**REPORT TO THE CALGARY PLANNING COMMISSION**

<b>DEVELOPMENT PERMIT</b>	<b>ITEM NO: 05</b>	
	CPC DATE:	2008 April 02
	DP NO:	DP2007-2199

**PROPOSAL:**  
Office building (15 storeys) with retail at grade

7.3 DESIGN RESPONSE  
LANDSCAPE PLAN

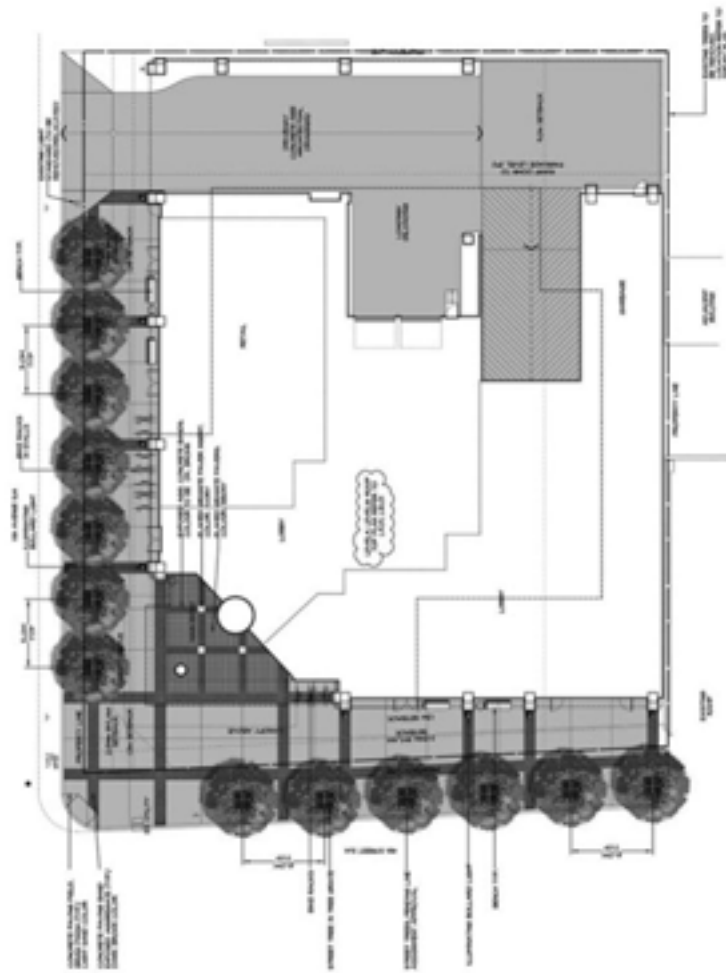
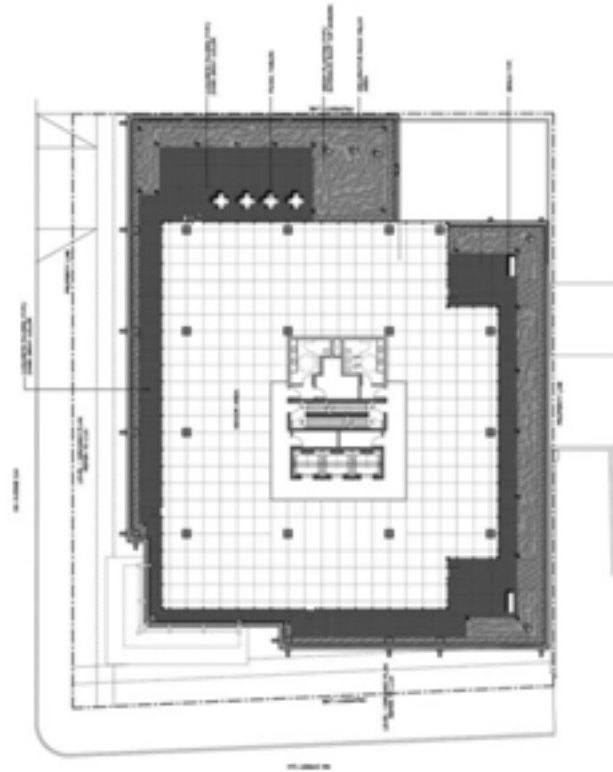
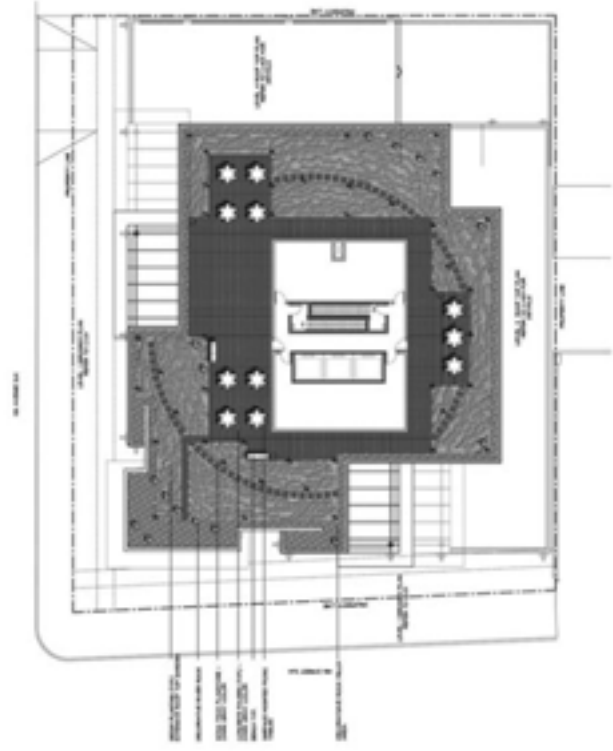
Regarding the outdoor terrace spaces on the 4<sup>th</sup> level, the applicant indicated the potential for plantings and other greening of this space. However, BPG feels it is appropriate that the candidate include a landscaping plan for this space. Vegetation would be visible from the ground level would add visual interest to the project. A true green roof would also have environmental benefits.
